Subject: Upper Floridan Monitoring Well Alternative Design, Koppers Inc. Site in
Gainesville, FL

Attachment A: Upper Floridan Monitoring Well Installation and Alternative Design

Figure 1. Temporary abandonment design for boreholes extending into the Upper Floridan Aquifer.

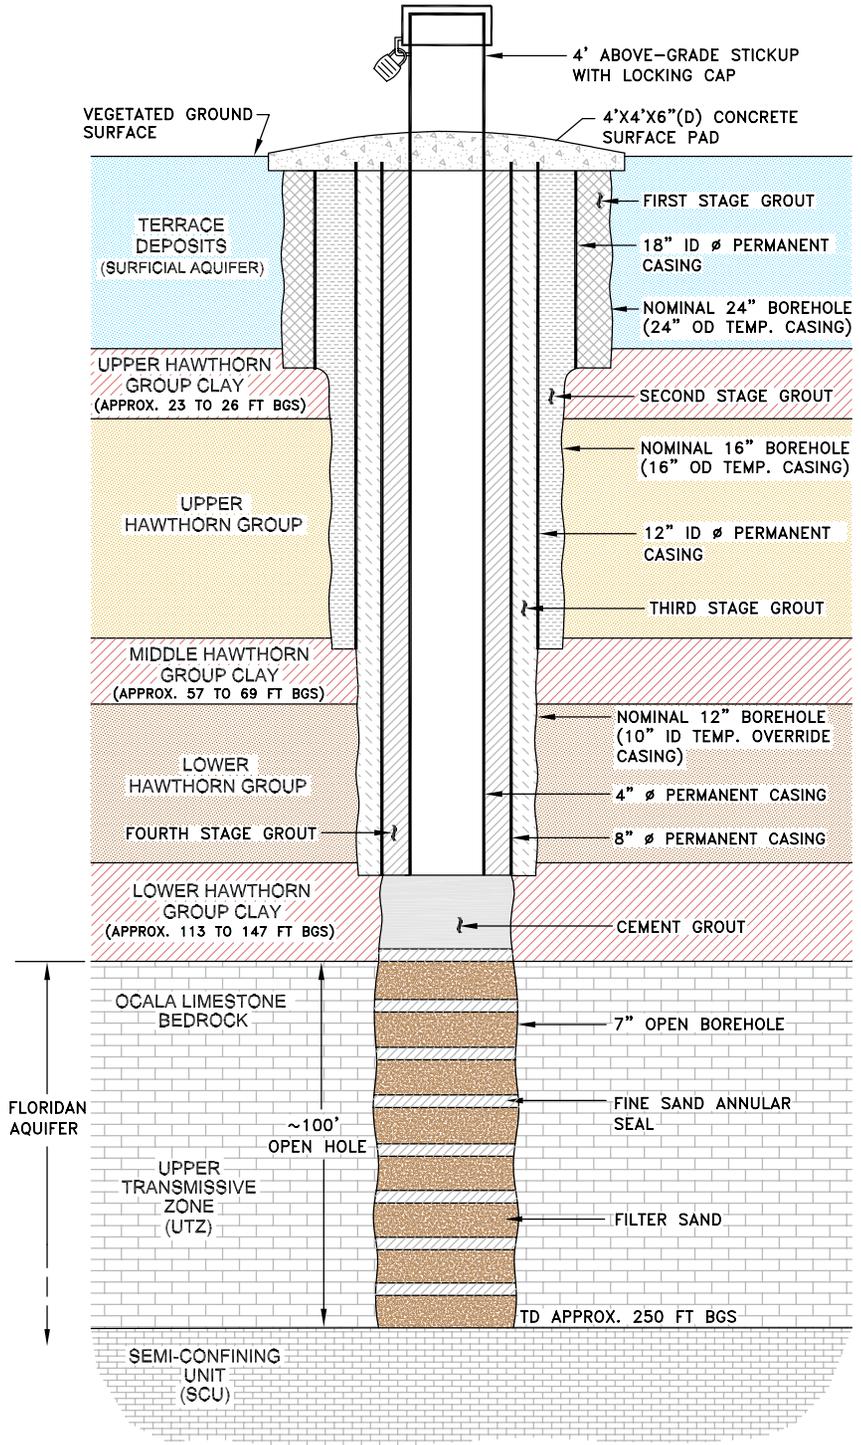
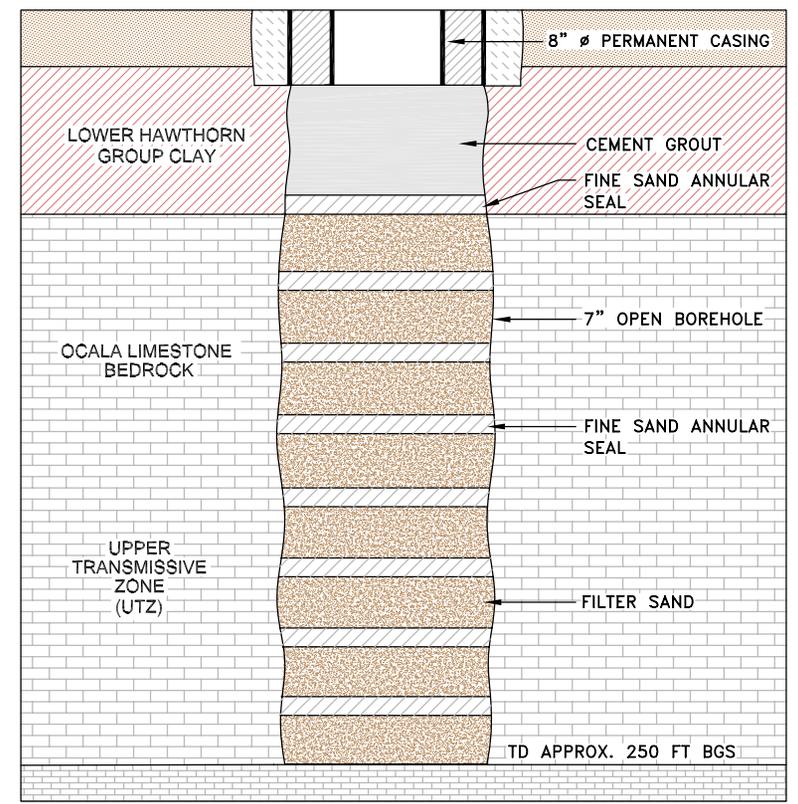
The U.S. EPA letter did not include a discussion of temporary well abandonment procedures for boreholes extending into the UF Aquifer. Figure 1 shows the conceptual design of well abandonment procedures performed for wells FW-10B, FW-12B and FW-14B. The temporary abandonment was performed to prevent vertical migration and mixing within the UF Aquifer, while the alternative well design was developed. The temporary abandonment basically consists of alternating layers of filter sand and low-permeability isolation sand over a 100-ft interval of the UF Aquifer. An approximately 30-ft cement grout plug was placed from the top of the UF Aquifer to the base of the 8” diameter isolation casing to minimize vertical migration within the lower Hawthorn Group clay unit. The abandonment design utilized for the UF Aquifer wells meets the criteria and specifications of the Saint Johns River Water Management District (SJRWMD) (Chapter 40C-3, F.A.C.).

Figure 2. Proposed alternative quadruple-cased Floridan aquifer well for the Upper Transmissive Zone, with multi-level screens and sampling system.

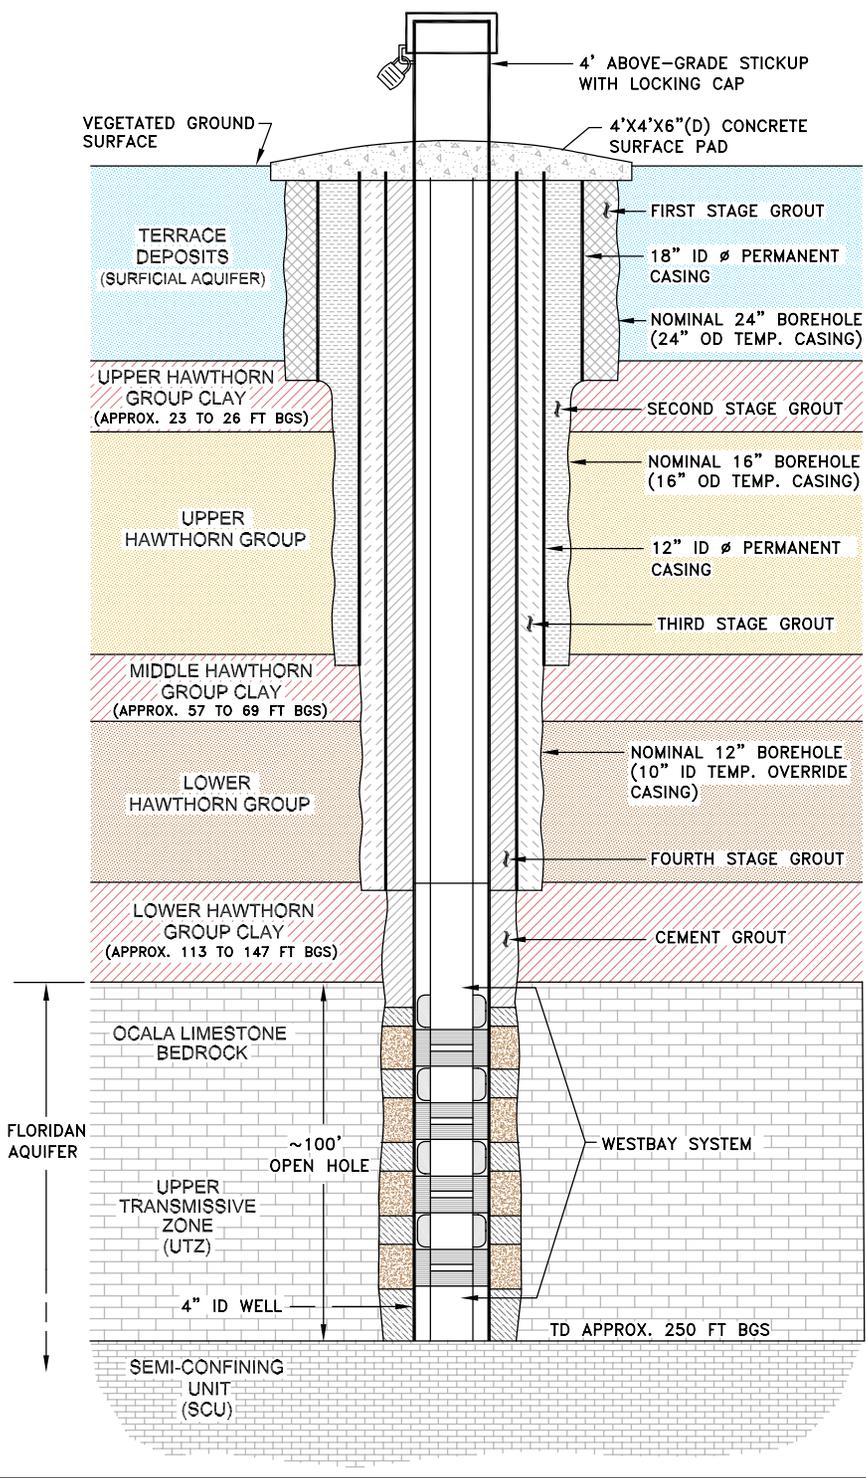
Well construction and logging details for the original well design are discussed in items 1 through 12 in the U.S. EPA letter. The alternative well design will result in modifications to items 5 through 9. Specifically, a nominal 8" diameter borehole will be drilled approximately 100 feet below the top of the UF Aquifer contact. In addition, geophysical logging is not possible for the alternative well design and therefore, will not be performed. A detailed discussion of the alternative well design and procedures are provided below. The conceptual design for an alternative well is shown in Figure 2.

- 1) The primary change to the original well design is the installation of four, 4" diameter, 10-ft well screens in place of the previously proposed open borehole beneath the 4" diameter well casing. The alternative well design will consist of 10-ft stainless-steel, wire-wrapped screens separated from each other by 10-ft of blank stainless-steel casing. Ten-ft well screen intervals are typically used with the Westbay sampling system to allow for the multi-level sampling and purge ports to be approximately centered across the 10-ft screen. A shorter 5-ft screen interval would result in the sampling and purge ports being located on the top and bottom of the screen interval making it more difficult to purge and sample the well. Approximately 15 ft of blank casing will also be installed at the bottom of the well to accommodate the multi-level sampling system specifications and approximately 10 ft of blank casing will be installed across the upper 10 ft of the UF Aquifer to accommodate the installation of annular sealant and grout below the lower Hawthorn Group clay unit. Approximately 40 ft of stainless steel blank casing will extend from the top of the upper screen interval to the base of the 8" diameter black steel isolation casing. The remaining well casing will consist of approximately 110 ft of black steel casing extending to land surface.

- 3) The alternative well design will be constructed the same as the original design, through the installation of the three isolation casings. The only change in the well design will be the installation of the 4" casing. The alternative well design requires that the rotasonic rig advance the 7" nominal diameter override casing to the completion depth of the well (approximately 100 ft into the UF Aquifer). The original well design only had the 7" override casing advancing 5 ft into the UF Aquifer, with a 3.8" borehole extending the remaining 95 ft. The 7" override casing needs to be extended to the completion depth of the well in order to construct the 4" diameter well inside of the override casing. The well construction technique is similar to the construction of a monitoring well inside of a hollow-stem auger. The override casing prevents the unconsolidated deposits from flowing into the borehole during the construction of the well. The alternating blank casing and screens within the UF Aquifer will consist of 15 feet of blank casing at the base of the well, followed by 10 feet of screen and 10 feet of blank casing extending to within 10 feet of contact of the lower HG clay with the UF Aquifer. The top

- of the uppermost screen will be approximately 10 feet below the contact of the lower Hawthorn Group clay and the UF Aquifer to allow for the placement of 5 ft of isolation material and 5 ft of cement grout below this contact.

- 4) Once the 7" override casing is advanced to the well completion depth and the drill cuttings have been flushed out of the inside of the casing, the 4" well will be constructed. The 4" well will be constructed by screwing flush-thread casing and screens together and lowering the assembled casing inside of the override casing. After the 4" casing and screens have been lowered to the completion depth, the screen filter pack and isolation material will be placed in the void space between the override casing and 4" well. The filter pack will be sized to match the screen slot size and the isolation material will consist of a fine, low-permeability sand, consistent with requirements of the SJRWMD. The void space opposite the 15 feet of blank casing at the base of the well will be backfilled with a fine sand isolation material. Once the isolation material has been placed, a coarse filter sand material will be placed opposite the screen interval extending approximately 1 foot below and 1 foot above the top of the screen interval. The alternating isolation material and filter sand material will progress upwards in the borehole until the upper screen filter material has been placed. Approximately 5 feet of isolation material will be placed above the uppermost screen interval to help prevent cement grout infiltration into the upper screen interval. A cement grout will extend from 5 ft above the upper screen interval to land surface.

- 5) The limited void space between the override casing (6.23" ID) and 4" well casing (4.5" OD) prevents the use of a tremmie pipe for the installation of the filter pack and isolation material. Therefore, all filter pack and isolation materials will be placed by pouring the material from land surface. To prevent bridging, the override and well casings will be vibrated during the material installation process. A measuring tape will be utilized during the material installation to tag the top of the filter pack and isolation material. In addition, the override casing will be slowly removed as the filter pack and isolation materials are placed. It is anticipated that the installation of the filter pack and isolation materials will require 1 to 1.5 days to complete to allow sufficient time for material settlement during the installation process.

- 6) After the final 5 ft of isolation material has been placed, the override casing will be completely removed from the borehole and a tremmie pipe will be installed to place the cement grout. The cement grout will be placed in two stages to help minimize cement contamination in the upper screen interval. The first grouting stage consists of placing approximately 35 feet of cement grout from the top of the isolation material to the base of the 8" isolation casing. This grout will be allowed to cure for 6 to 12 hrs before grouting the well to land surface.
